Errata Sheet

Rel. 1.2, 03.12.2010

Device	**XC835/836MT Series**
Marking/Step	**AB**
Package	**PG-TSSOP-28/DSO-24**

Figure 1 Counting sequence of T12 in center-aligned mode

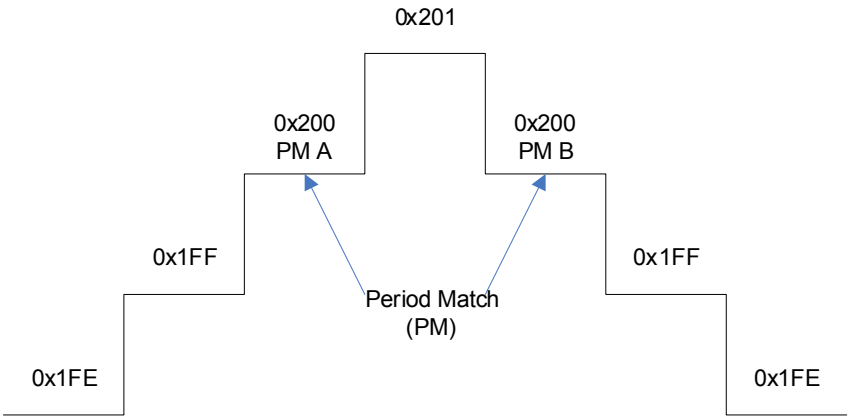
CCU6_XC8.H002 CCU6 PM event in center-aligned mode

After detecting a period match (PM A) in centre-aligned mode, T12 counts down from PM + 1 as shown below:

This means a second PM event (PM B) will occur during the counting down. If ADC is triggered externally via REQTRxC (T12PM), it will be triggered twice in succession. Depending on how real-time the application code is running as well as the T12 count rate and ADC conversion rate, the application could observe two ADC interrupts - once at PM A and once at PM B.

To avoid triggering twice the ADC interrupts, it is suggested to use REQTRxF from multi-channel mode instead of REQTRxC as the trigger source for ADC. Additional initialization are as follows:

- Configure MCMCTR.SWSEL = 101_B (Transfer on T12 period match)
- Configure MCMCTR.SWSYN = 00_B (Direct transfer)
- Write to MCMOUTSTL = CF_H (To enable multi-Channel PWM pattern on CC6x and COUT6x)
